I-90
CABIN CREEK I/C TO W EASTON I/C
PHASE 3 - ADD LANES/WILDLIFE BRIDGES

UNNAMED CREEK (MP 65.1) SITE PLANS

PLAN REF NO
CR3-2

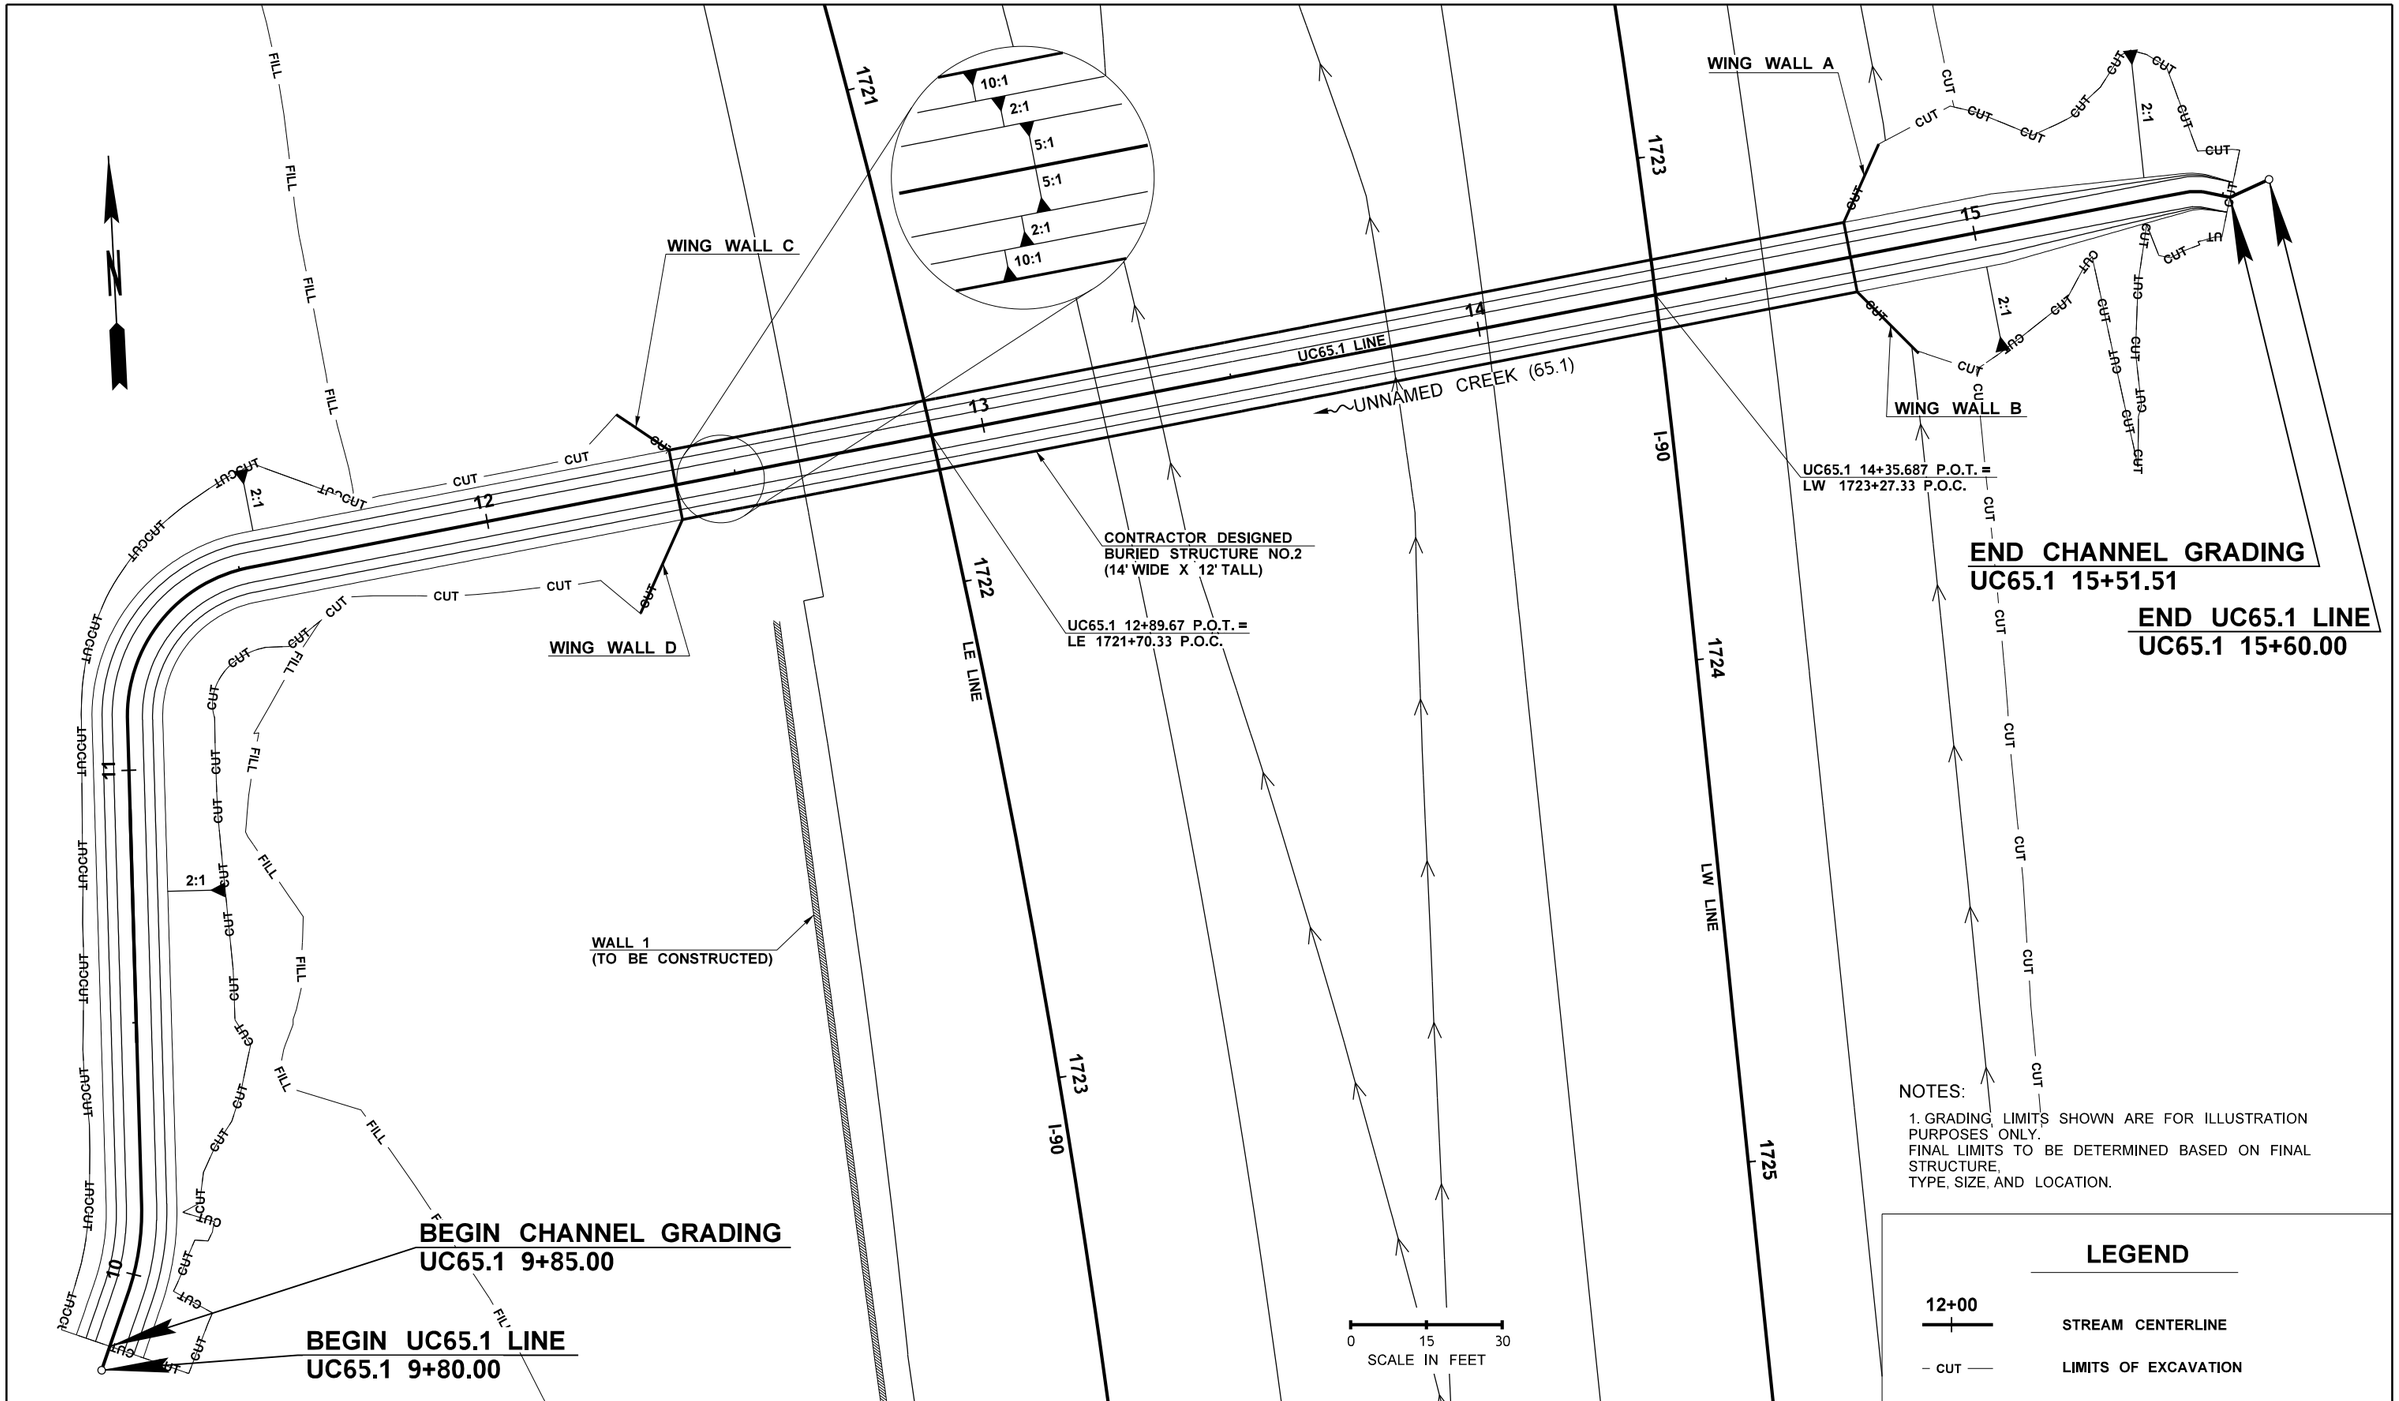
LWM - TYPE A - 30" DBH X 30' LONG		10 ~~(16~~ EACH)
LWM - TYPE ~~B~~ C - 24" DBH X ~~30'~~ 20' LONG		9 ~~(6~~ EACH)
LWM - TYPE ~~D~~ E - 20" DBH X ~~15'~~ 10' LONG		9 ~~(19~~ EACH)
STREAMBED BOULDER THREE MAN		27 (9 EACH)

This is the count for only the in-stream LWM. We had discussed separating out the habitat logs which include the Type B on the cascade slope and logs in the existing channel. Add the habitat logs below the in-stream logs

Add more LWM as needed

ADDITIONAL LWM

LWM - TYPE A - 30" DBH X 30' LONG (7 EACH)

LWM - TYPE B - 24" DBH X 20' LONG (4 EACH)

UC65.1 - SECTION A

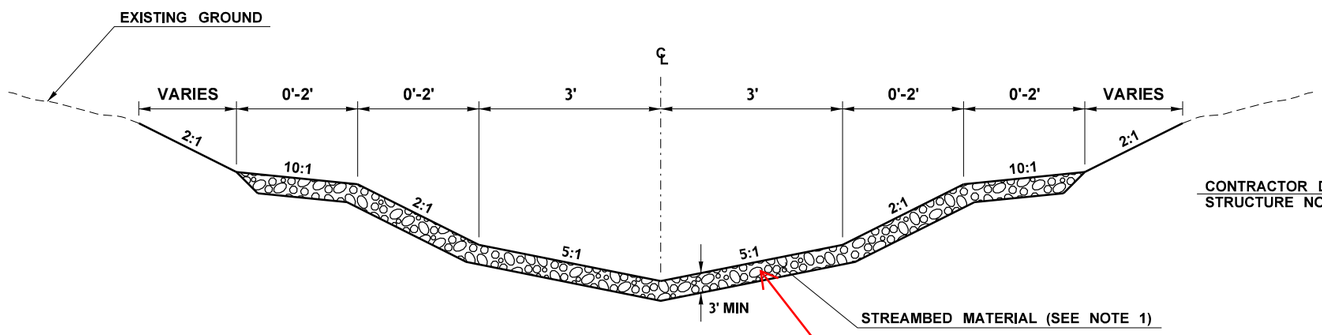
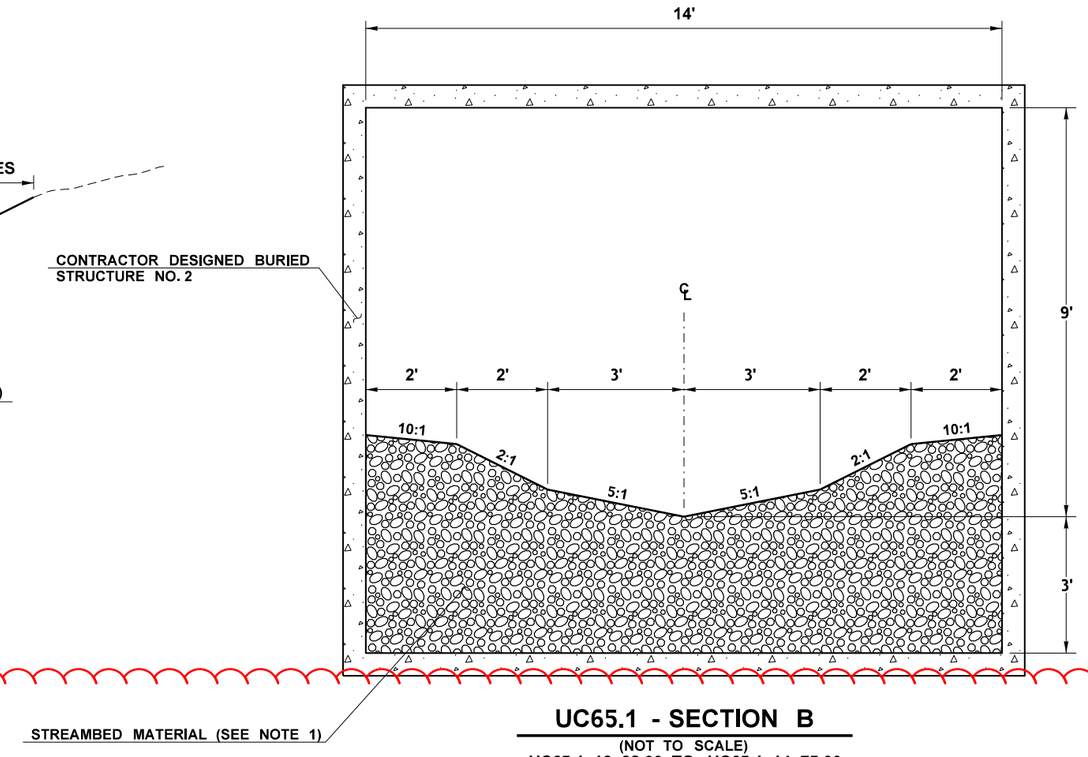
Need to distinguish different types of streambed material vs Class C Rock

These are typically not shown on the stream sheets.

PLAN REF NO CR3-6

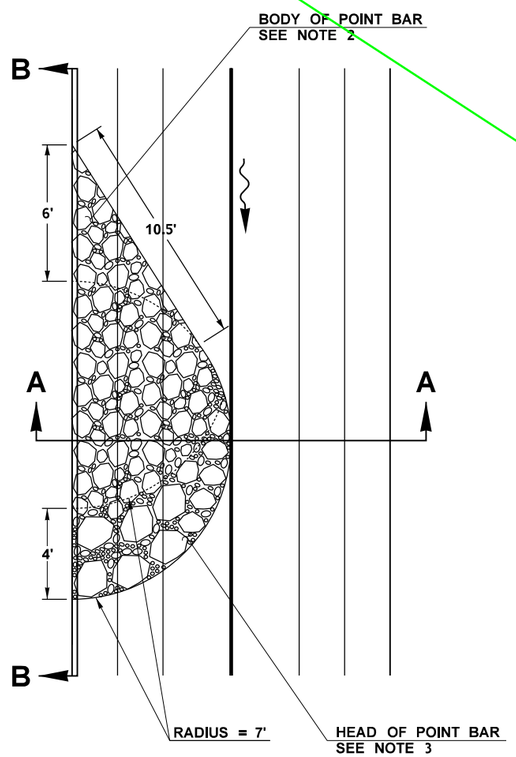
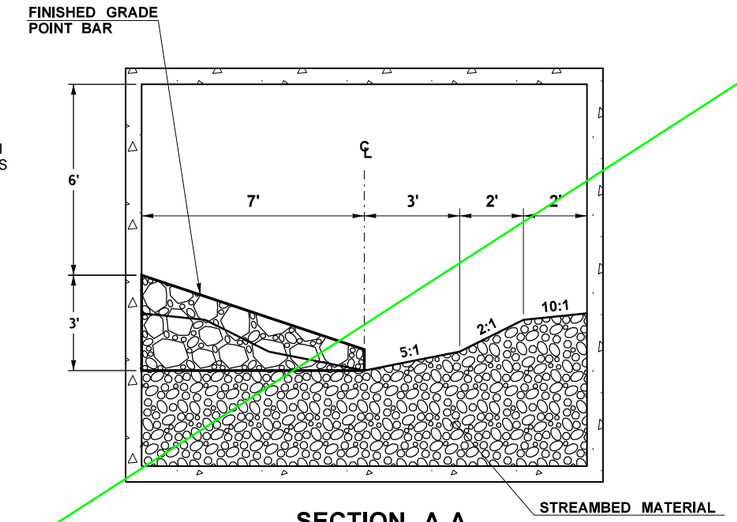
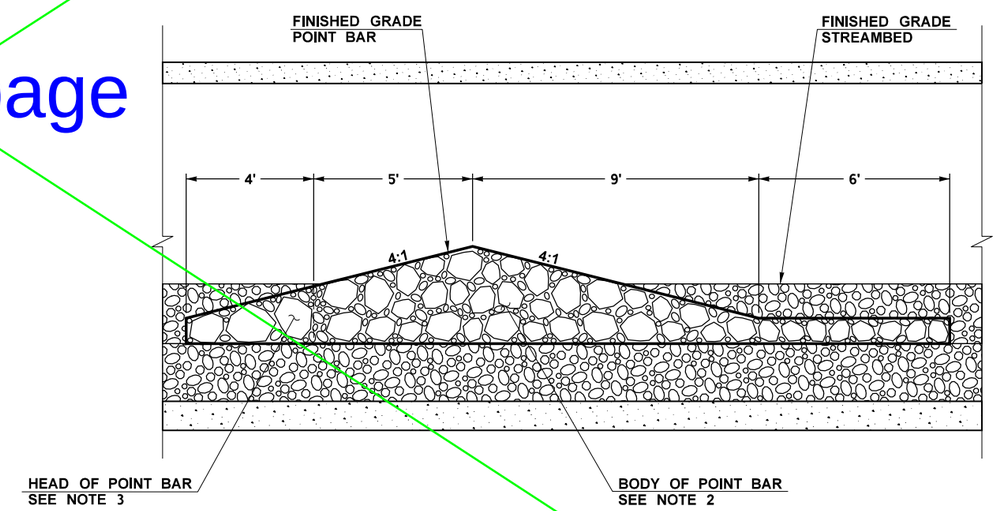
Delete page
